Access Compliance Report

Public Rights-of-Way

Intersection ID: 42950	Main Street: BENZIGER_CT	Cross Street: LONG_PAW_LN	Location: SE
ADA ID: BAC30FCFE50C	Ramp Type: PerpDiag	Initial Pass/Fail: Fail	Overall Compliance: No
Severity Score: 13.75			
Codes/Mitigation Info/Possible Solution		Field Measurements/Component Compliance

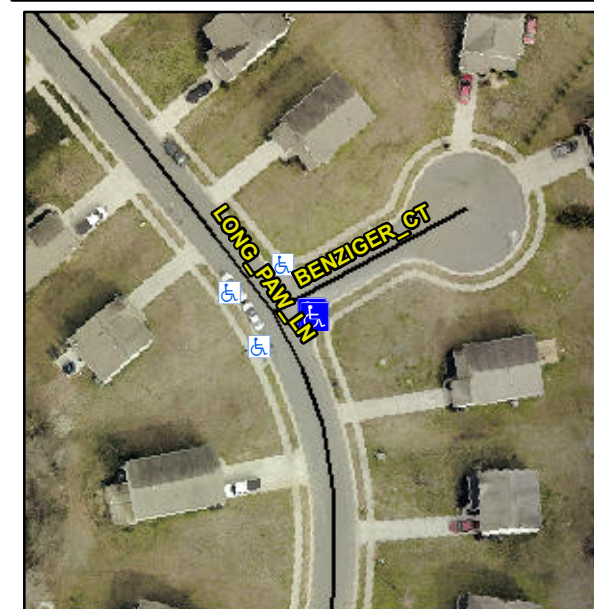
Not Found, R304.2.2, R304.5.3

Compliance	Description	Data	Compliance	Description	Data
N/A	Ramp Length (in)	48.0	No	Ramp Slope (%)	8.5
Yes	Ramp Width (in)	48.0	No	Ramp XSlope (%)	2.1
N/A	Flare Type LT	N/A	N/A	Flare Type RT	N/A
N/A	Flare Slope LT (%)	N/A	N/A	Flare Slope RT (%)	N/A
N/A	Flare Traversable LT?	N/A	N/A	Flare Traversable RT?	N/A
N/A	Landing Length (in)	N/A	N/A	DWS Provided?	N/A
N/A	Landing Width (in)	N/A	N/A	DWS Contrast?	N/A
N/A	Landing Slope (%)	N/A	N/A	DWS Length (in)	N/A
N/A	Landing X Slope (%)	N/A	N/A	DWS Full Width?	N/A
N/A	Landing Curb? (Y/N)	N/A	N/A	DWS Offset (in)	N/A
N/A	Shared Landing?	N/A			
N/A	Gutter Ponding?	N/A	N/A	Gutter Slope (%)	N/A
N/A	Gutter Lip Ht (in)	N/A	N/A	Gutter X Slope (%)	N/A
N/A	Painted X Walk1?	No	N/A	Painted X Walk2?	No
	X Walk 1 Direction	To N		X Walk 2 Direction	To W
N/A	X Walk 1 Width (in)	N/A	N/A	X Walk 2 Width (in)	N/A
	X Walk 1 Slope (%)	1.3		X Walk 2 Slope (%)	4.6
	X Walk 1 X Slope (%)	1.8		X Walk 2 X Slope (%)	1.2

Remove & Replace Curb Ramp With Two New Directional Ramps or Equivalent.
